STATE OF DELAWARE
DEPARTMENT OF TRANSPORTATION
800 BAY ROAD
P.O. BOX 778
DOVER, DELAWARE 19903

February 14, 2025

RE: Agreement No. 1946F
Traffic Impact Study Services
Task No. 5A Subtask 16A – 5563 Dupont Parkway

McCormick Taylor has completed its review of the Traffic Impact Study (TIS) for the 5563 Dupont Parkway development prepared by Bowman Consulting Group, Ltd., dated August 28, 2024. Bowman prepared the report in a manner generally consistent with DelDOT's Development Coordination Manual.

Scope of Improvements Figure
5563 Dupont Parkway TIS

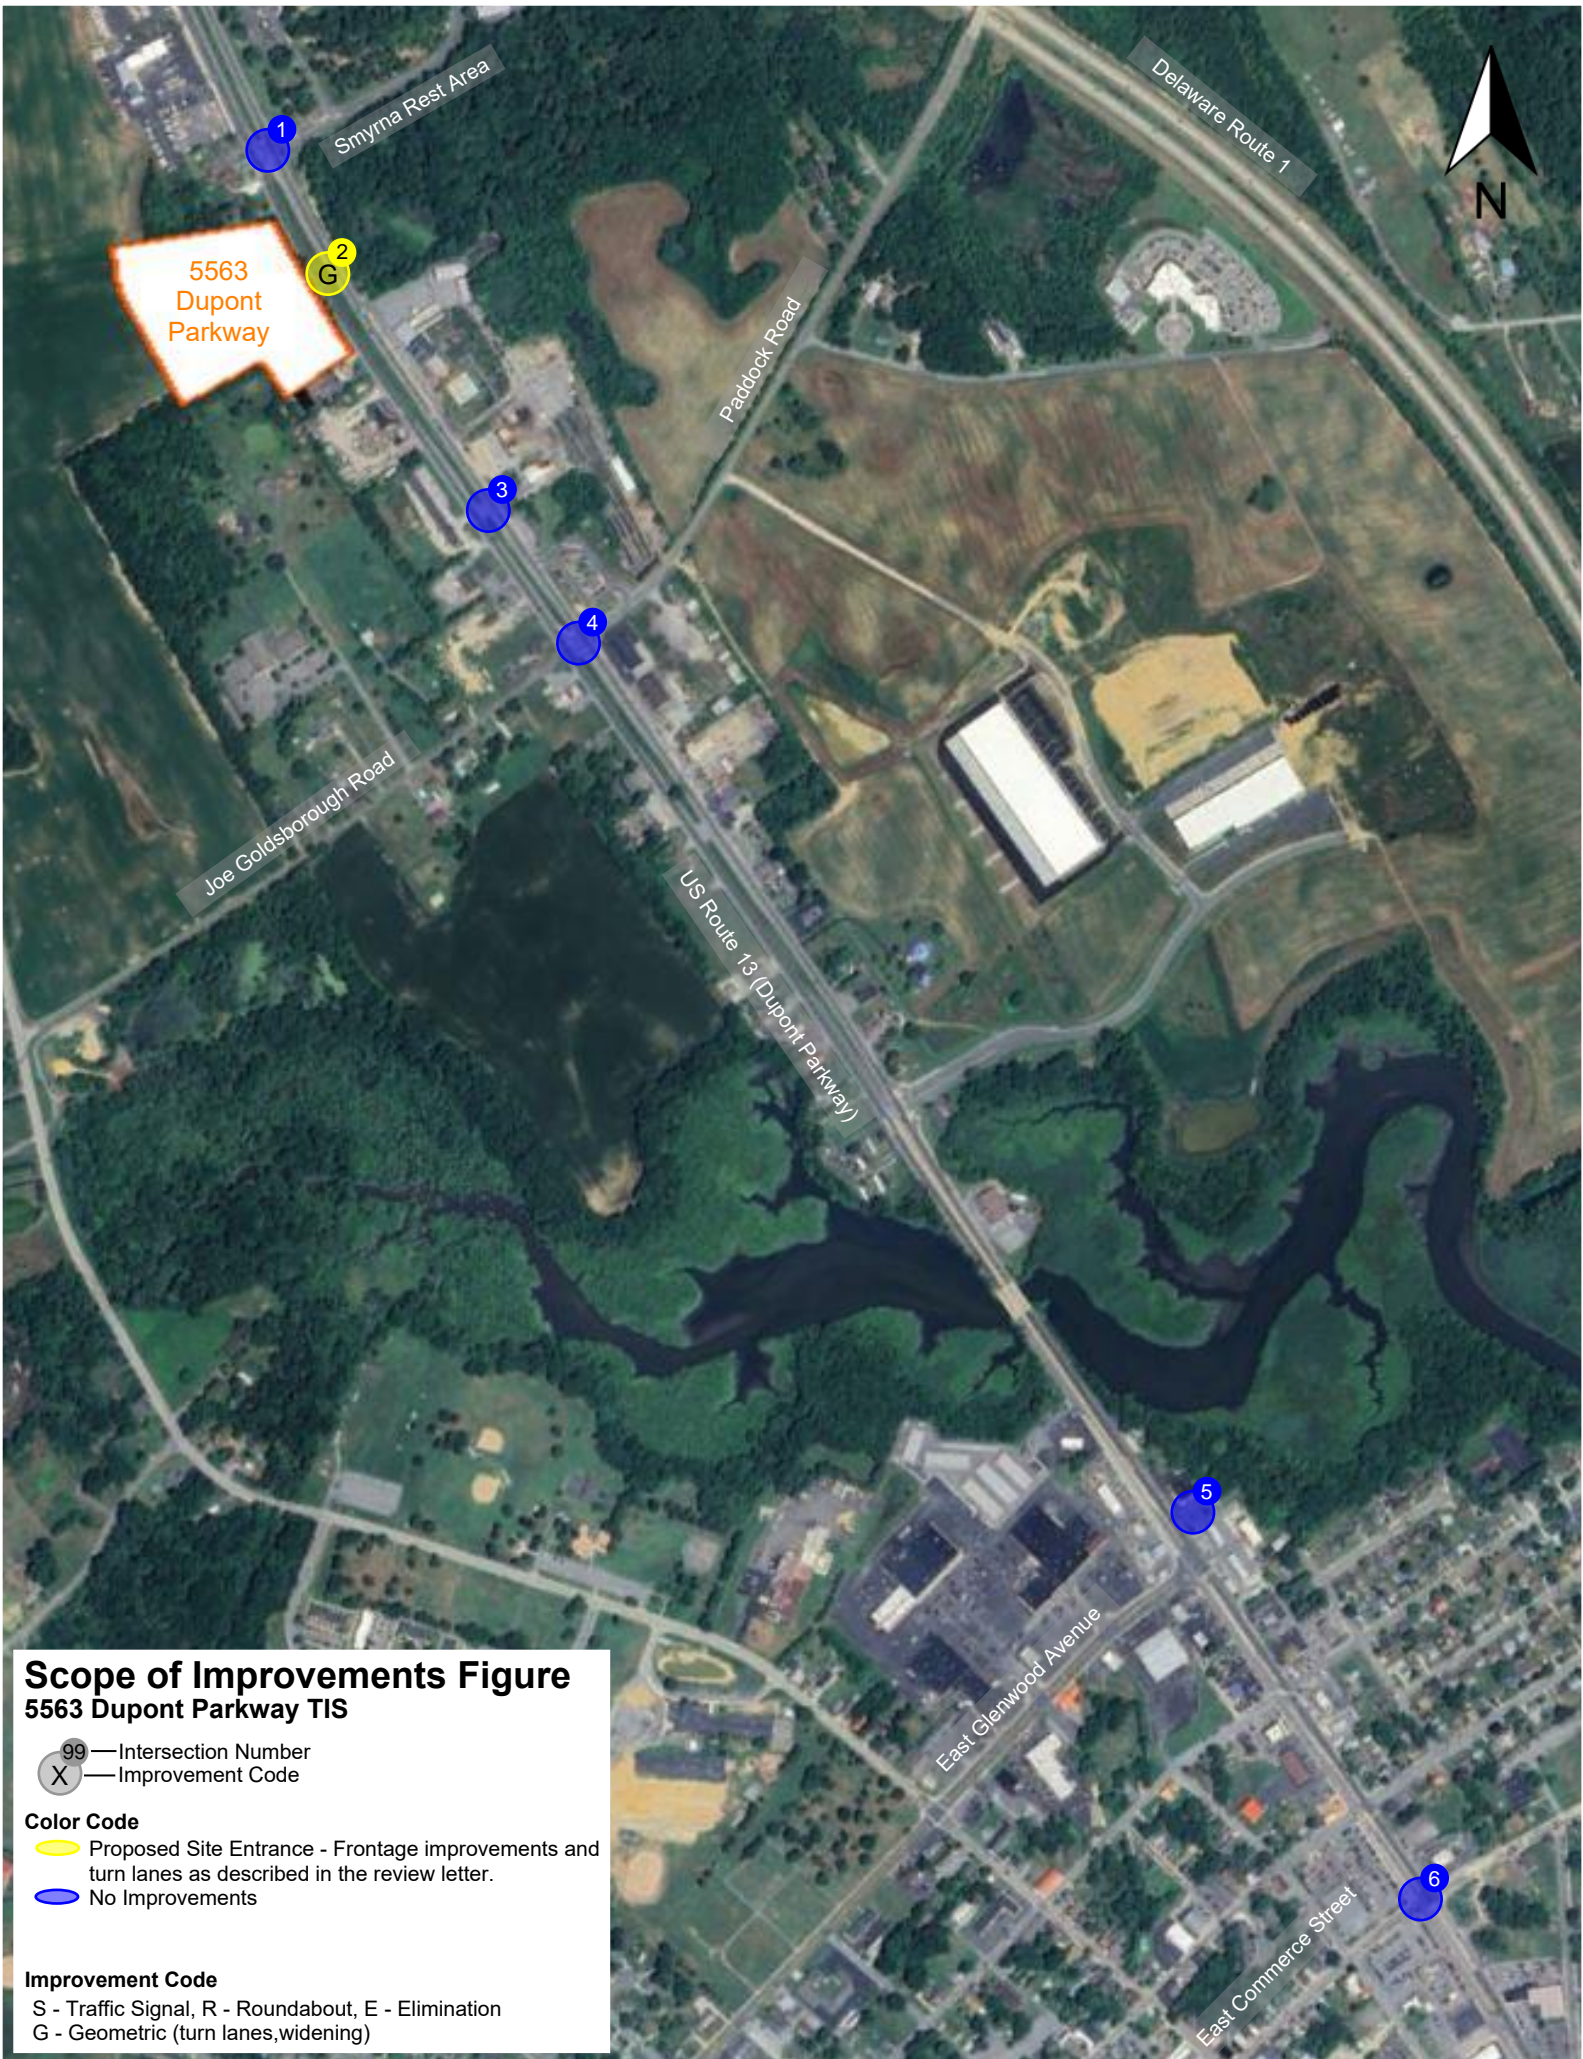
2. The developer should construct the right-in/right-out Site Entrance on US Route 13. The proposed configuration is shown in the table below.

At the proposed Site Entrance intersection, a southbound right-turn lane is warranted on US Route 13 based on DelDOT's Auxiliary Lane Worksheet. Initial recommended minimum turn lane length (excluding taper) includes a 410-foot right-turn lane on southbound US Route 13. However, due to storage length limitations as a result of the distance between the Site Entrance and the adjacent traffic signal at the Smyrna Rest Area, the developer should coordinate with DelDOT's Development Coordination Section to determine final turn lane lengths and other design details during the site plan review.

3. The following bicycle and pedestrian improvements should be included:
 - a. Per the DelDOT Development Coordination Manual section 5.2.9.2, bicycle lanes are required where right-turn lanes are being installed.

- b. Utility covers should be made flush with the pavement.
 - c. A minimum 15-foot-wide permanent easement from the edge of the right-of-way should be dedicated to DelDOT within the site frontage along US Route 13. Along the frontage, a minimum of a 10-foot wide shared-use path should be constructed. The shared-use path should meet AASHTO and ADA standards and should have a minimum of a five-foot buffer from the roadway. At the property boundaries, the shared-use path should connect to the adjacent property or to the shoulder in accordance with DelDOT's Development Coordination Manual. The developer shall coordinate with DelDOT's Development Coordination Section through the plan review process to determine the details of the shared-use path design location and connections/terminations.

- f. Construct one new Type 2 (17'x8') bus stop on southbound US Route 13, just south of the proposed site entrance. Bus stop pads should connect to shared use paths and sidewalks. Location, size, and type of bus stop pad will be determined through coordination with the Delaware Transit Corporation (DTC) and DelDOT's Subdivision Section during the plan review process.
